National Committee on Uniform Traffic Control Devices

1
2 **National Committee on Uniform Traffic Control Devices (NCUTCD)**
3 **Recommended Changes to Proposed Text for 11th Edition of the MUTCD**
4 **Docket Number: FHWA-2020-0001**

5 **Federal Register Item Number:** 516

6 **NPA MUTCD Section Number:** Section 6P.01

1042
1043 **Figure 6P-23. Lane Closure on the Far Side of an Intersection (TA-23)**
1044

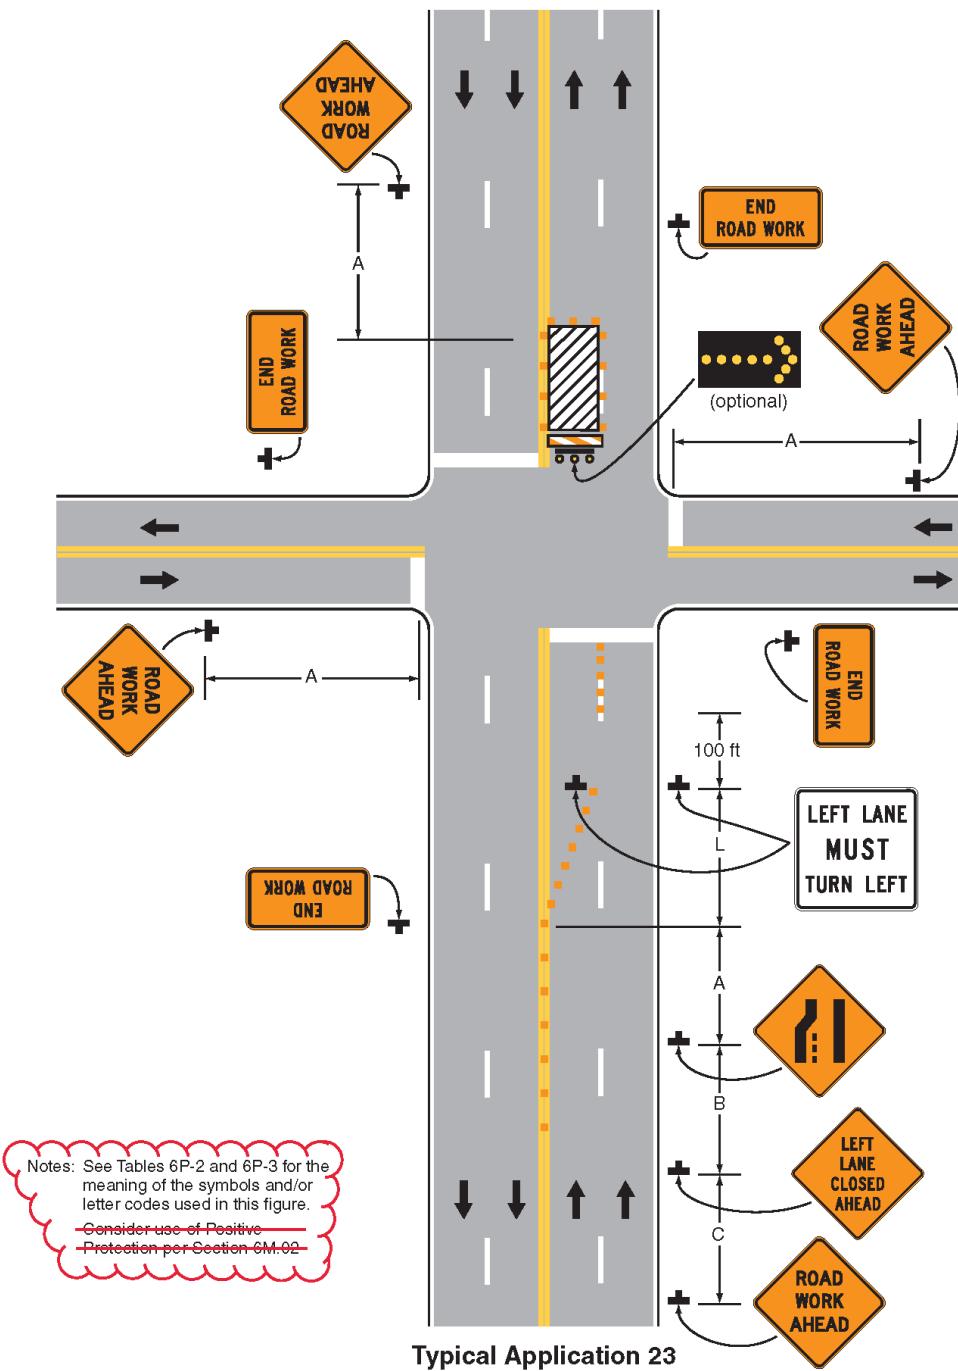
1039 **Figure 6P-23 Comments:** NCUTCD generally agrees with Figure 6P-23 as presented in the
1040 NPA, but recommends deleting the positive protection note since it is redundant with a note
1041 added to the notes page.

Figure 6P-24. Half Road Closure on the Far Side of an Intersection (TA-24)

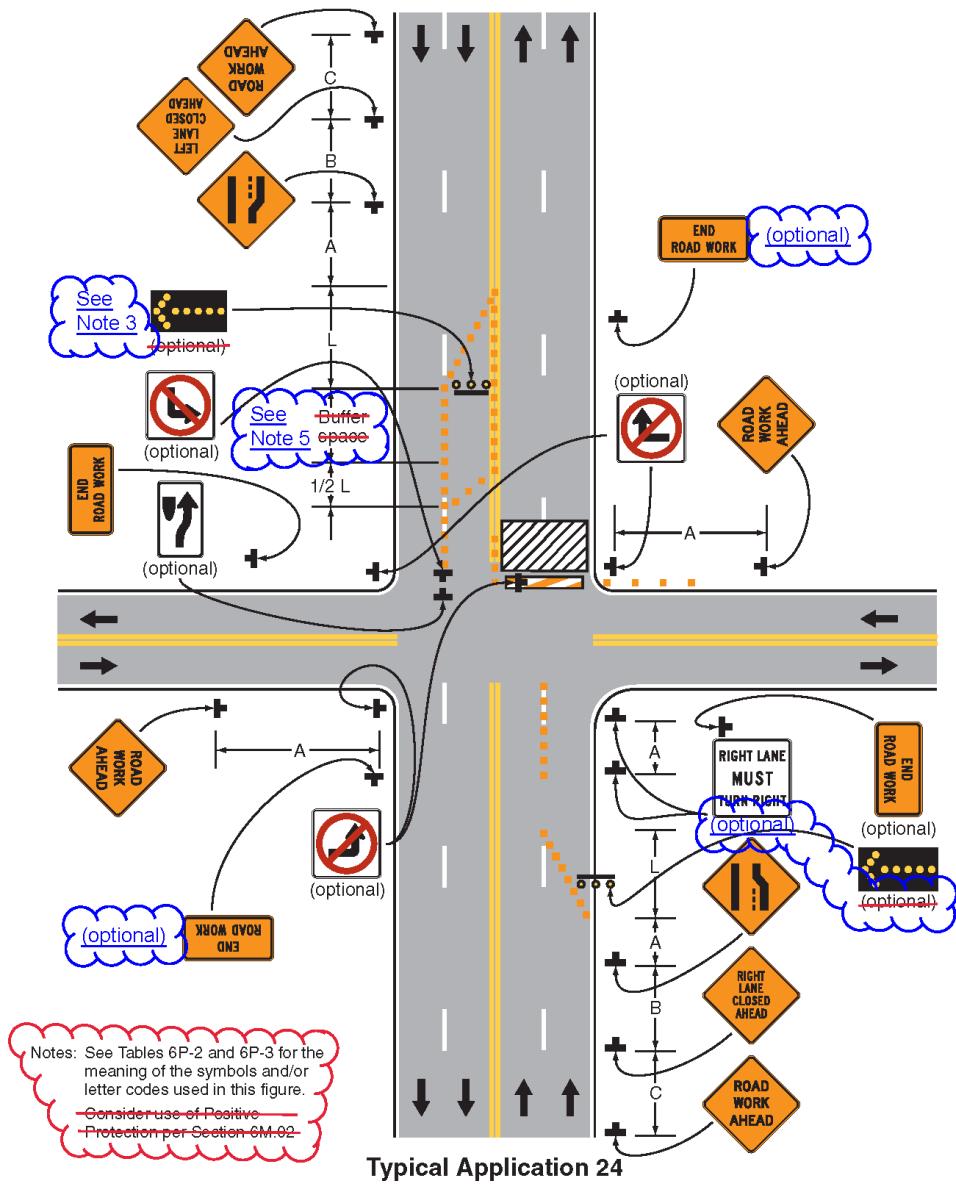
Figure 6P-24 Comments: NCUTCD generally agrees with Figure 6P-24 as presented in the NPA, but recommends revising in accordance with NCUTCD recommendation 20B-TTC-01 as follows:

- Delete a new positive protection note in the typical application figure since it is redundant with a note added to the notes page
- Relocate the “(optional)” text from under the arrow board to be under the RIGHT LANE MUST TURN RIGHT sign

1127 **Figure 6P-25. Multiple Lane Closures at an Intersection (TA-25)**
1128

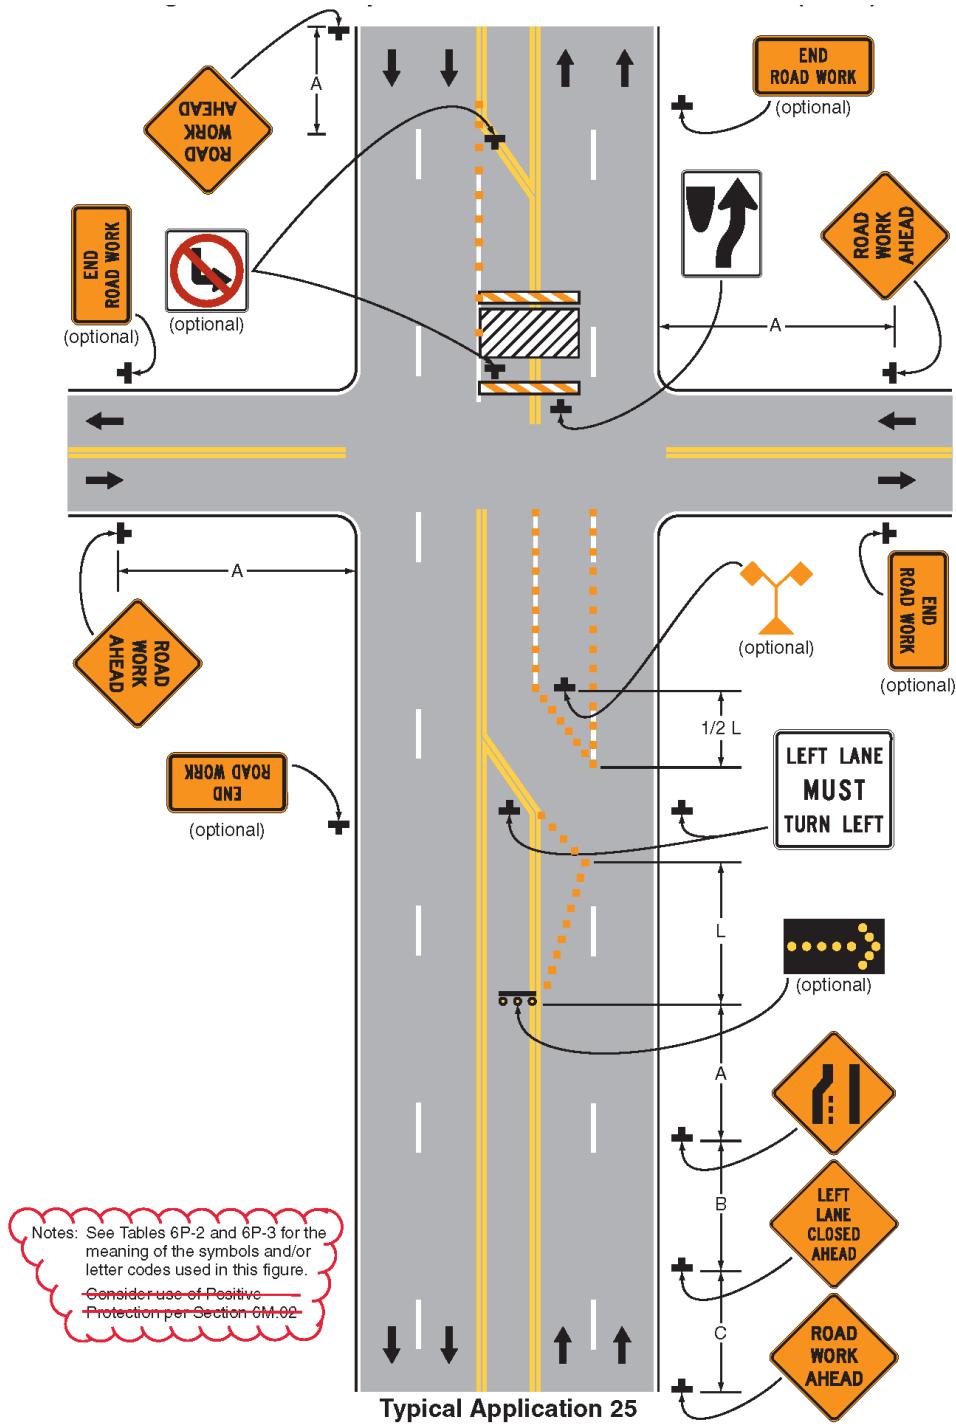
1123
1124 **Figure 6P-25 Comments:** NCUTCD generally agrees with Figure 6P-25 as presented in the
1125 NPA, but recommends deleting a new positive protection note in the typical application figure
since it is redundant with a note added to the notes page.
1126

1205 **Figure 6P-27. Closure at the Side of an Intersection (TA-27)**

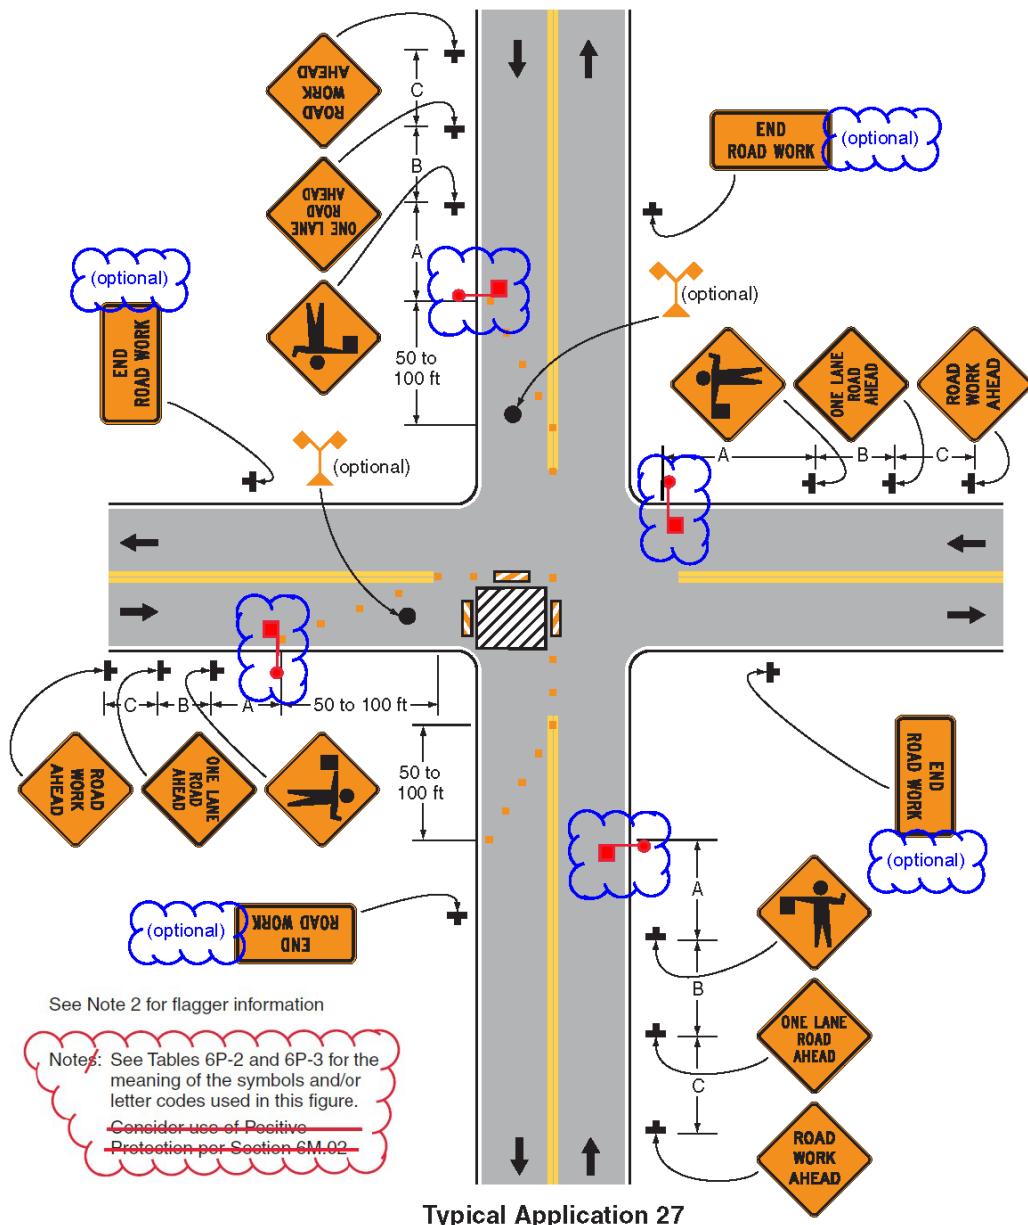
1198 **Figure 6P-27 Comments:** NCUTCD generally agrees with Figure 6P-27 as presented in the
1199 NPA, but recommends revising in accordance with NCUTCD recommendation 20B-TTC-01 as
1200 follows:
1201

1295
1296 **Figure 6P-29. Crosswalk Closures and Pedestrian Detours (TA-29)**

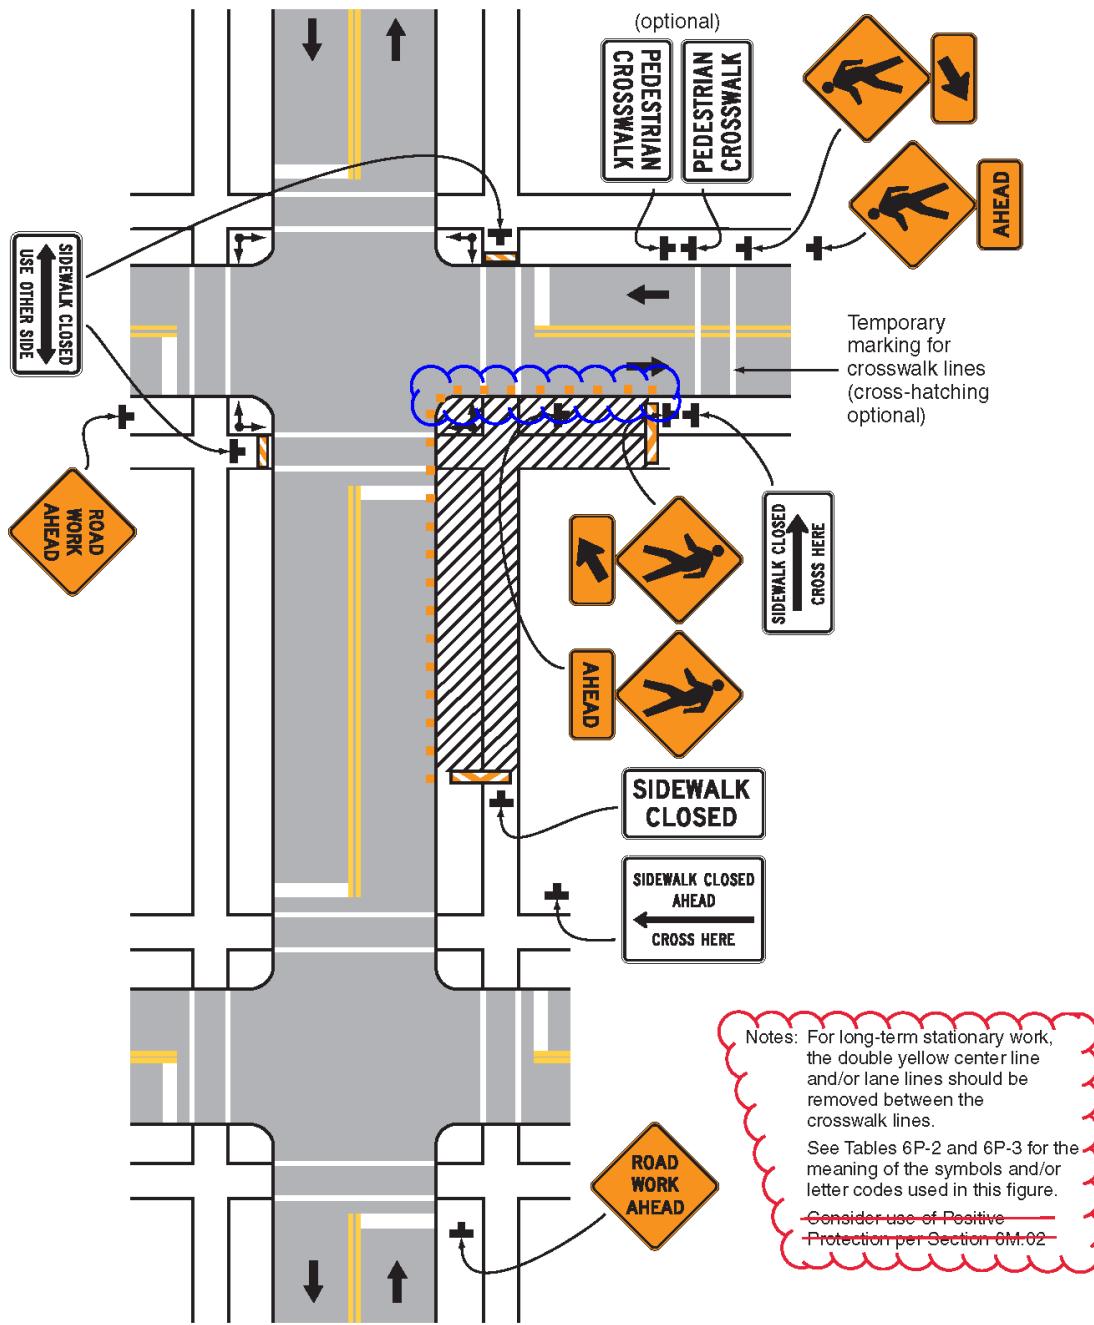
1290 **Figure 6P-29 Comments:** NCUTCD generally agrees with Figure 6P-29 as presented in the
1291 NPA, but recommends revising as follows:
1292 • Delete a new positive protection note in the typical application figure since it is redundant
1293 with a note added to the notes page
1294 • Add channelizing devices along the work space of the cross street

1339 **Figure 6P-30. Interior Lane Closure on a Multi-Lane Street (TA-30)**

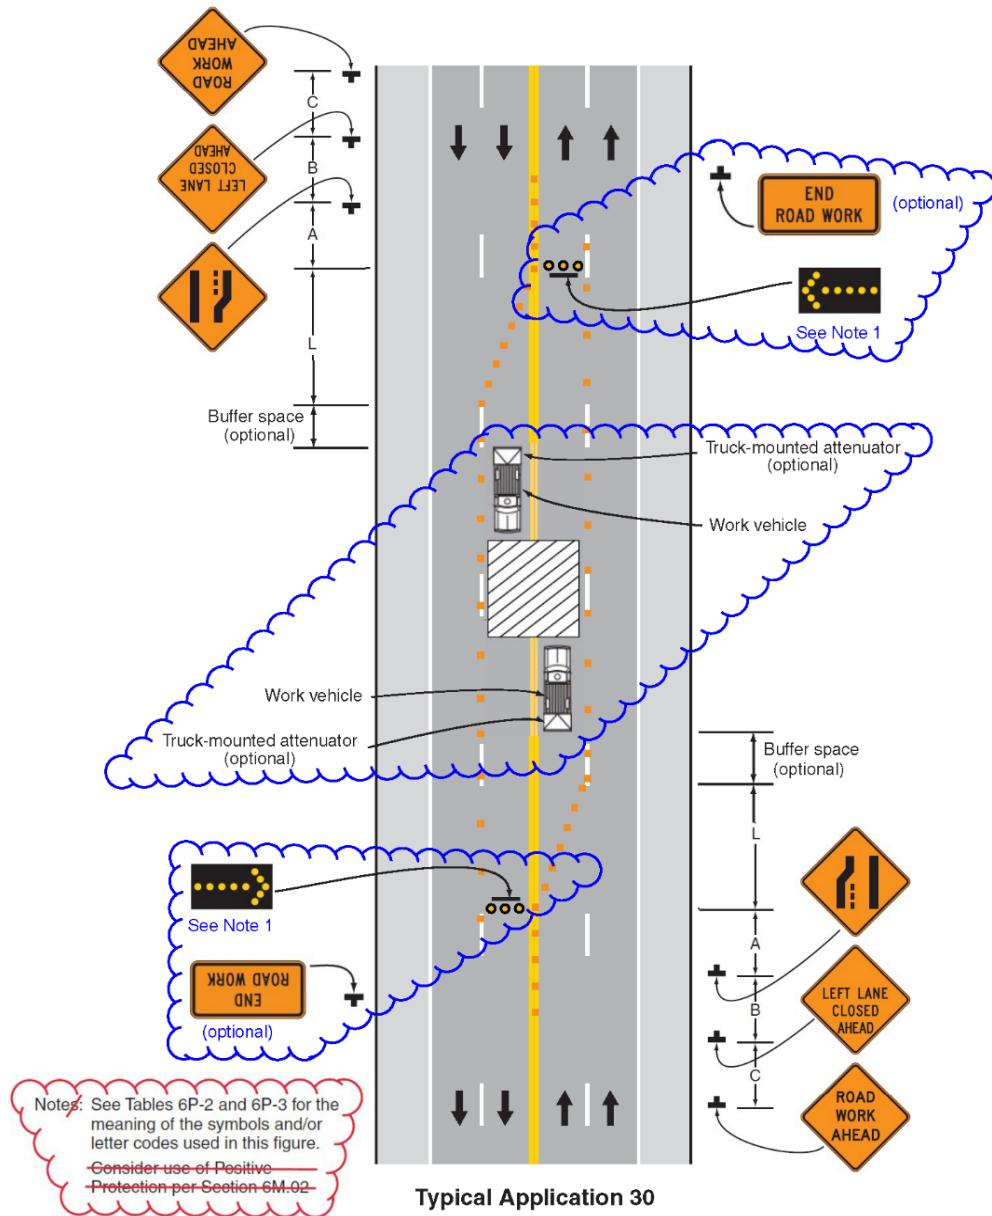
1331 **Figure 6P-30 Comments:** NCUTCD generally agrees with Figure 6P-30 as presented in the
1332 NPA, but recommends revising in accordance with NCUTCD recommendation 20B-TTC-01 as
1333 follows:

1405
1406
1407
1408
1409
1410
1411
1412 **Figure 6P-31. Lane Closure on a Street with Uneven Directional Volumes (TA-31)**

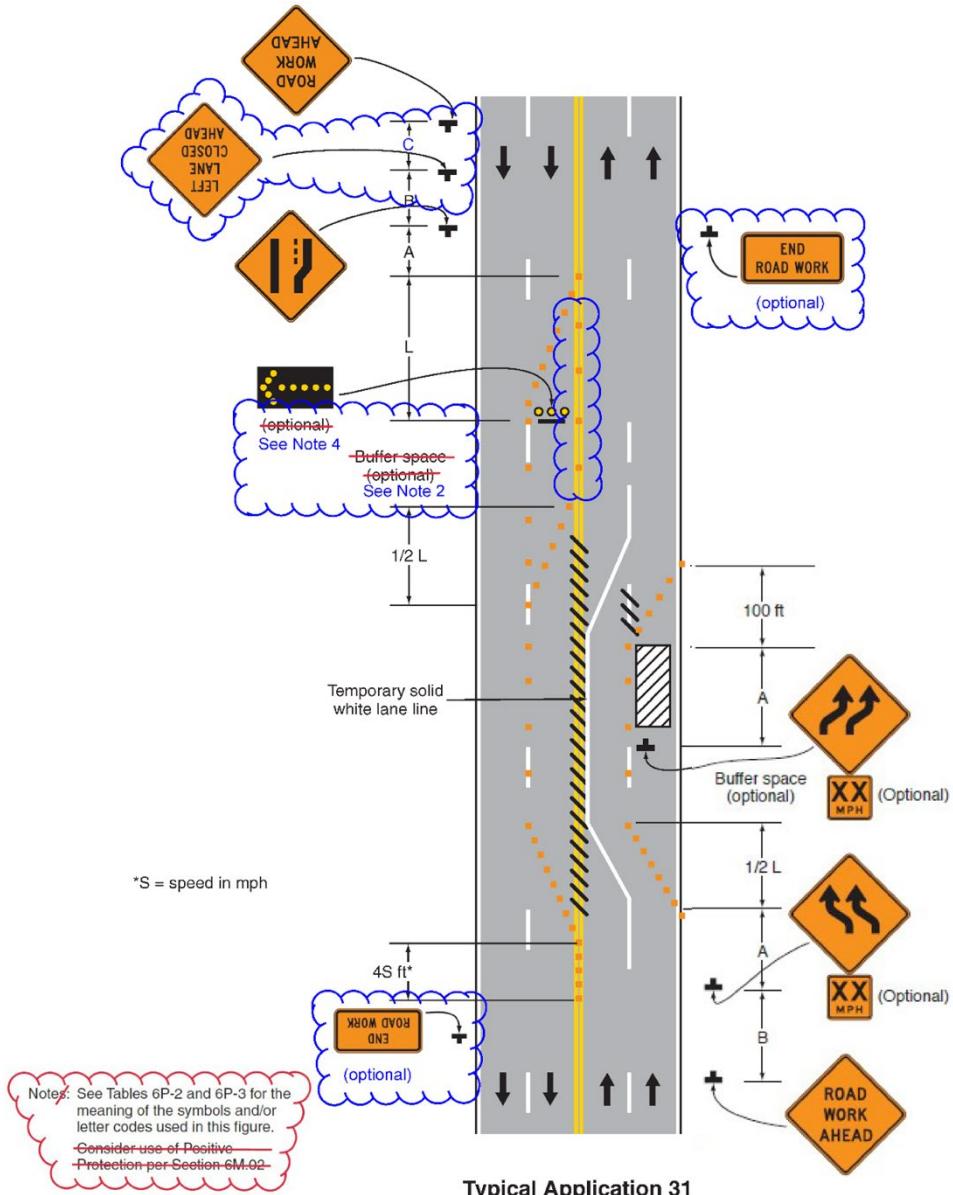
1402 **Figure 6P-31 Comments:** NCUTCD generally agrees with Figure 6P-31 as presented in the
1403 NPA, but recommends revising in accordance with NCUTCD recommendation 20B-TTC-01 as
1404 follows:

1461 **Figure 6P-32. Half Road Closure on a Multi-Lane, High-Speed Highway (TA-32)**

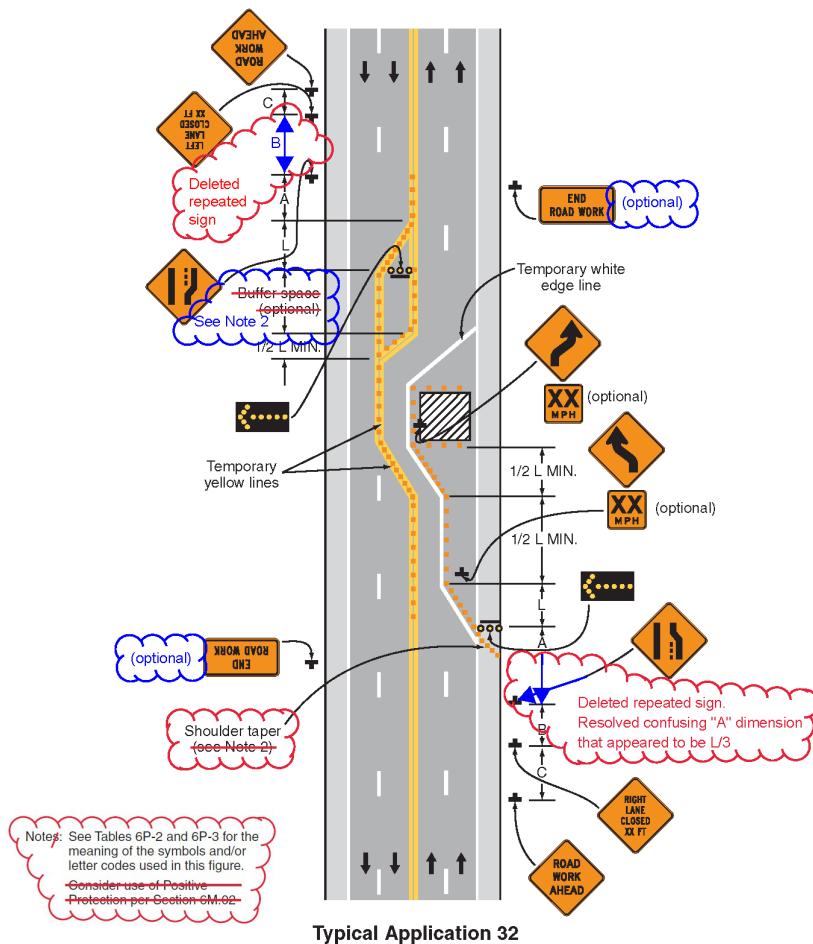
1453 **Figure 6P-32 Comments:** NCUTCD generally agrees with Figure 6P-32 as presented in the
1454 NPA, but recommends revising in accordance with NCUTCD recommendation 20B-TTC-03 as
1455 follows:

1504
1505
1506
1507
1508
1509
1510
1511 **Figure 6P-33. Stationary Lane Closure on a Divided Highway (TA-33)**

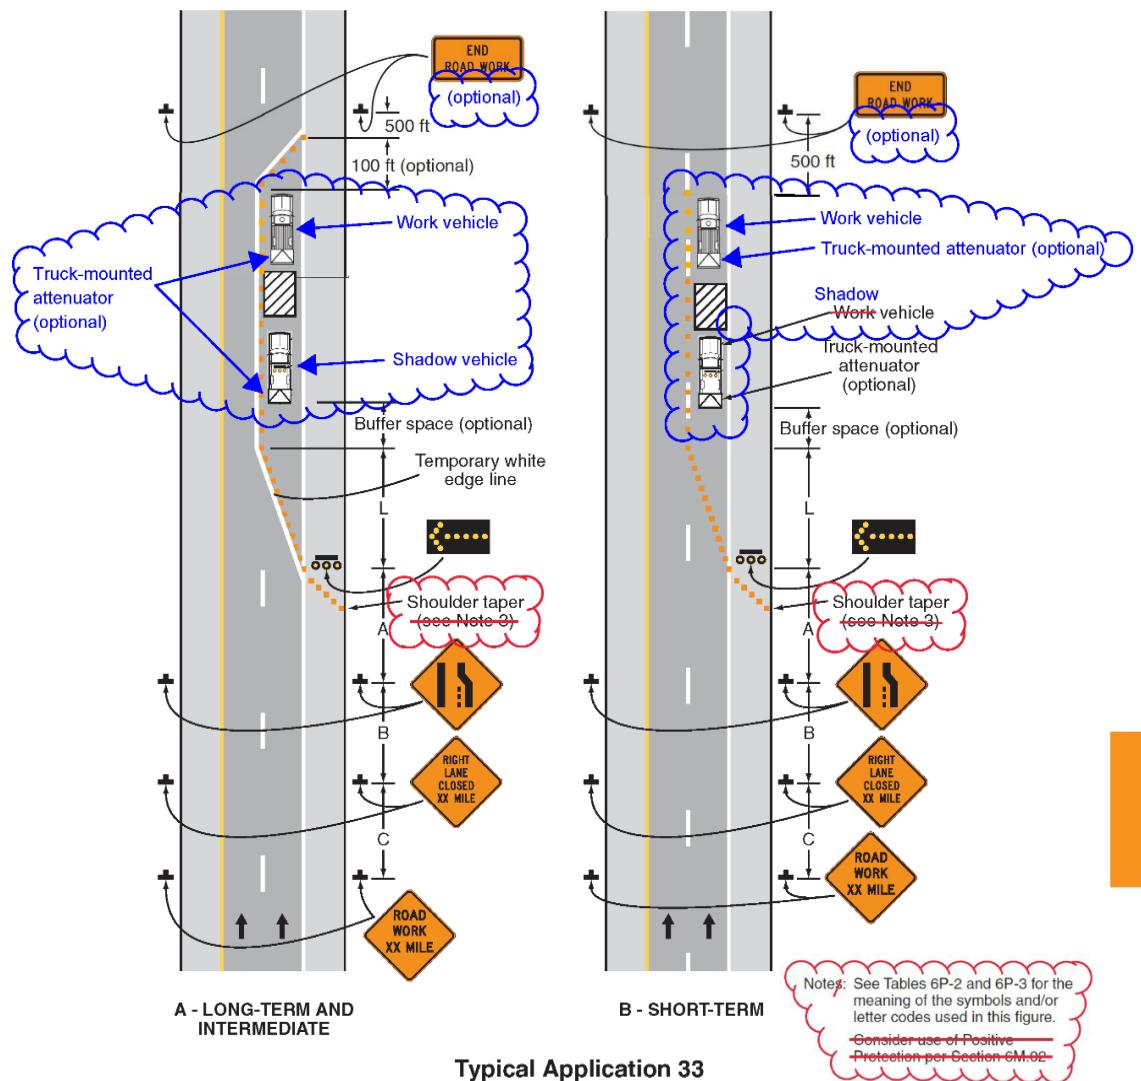
1501 **Figure 6P-33 Comments:** NCUTCD generally agrees with Figure 6P-33 as presented in the
1502 NPA, but recommends revising in accordance with NCUTCD recommendation 20B-TTC-03 as
1503 follows:
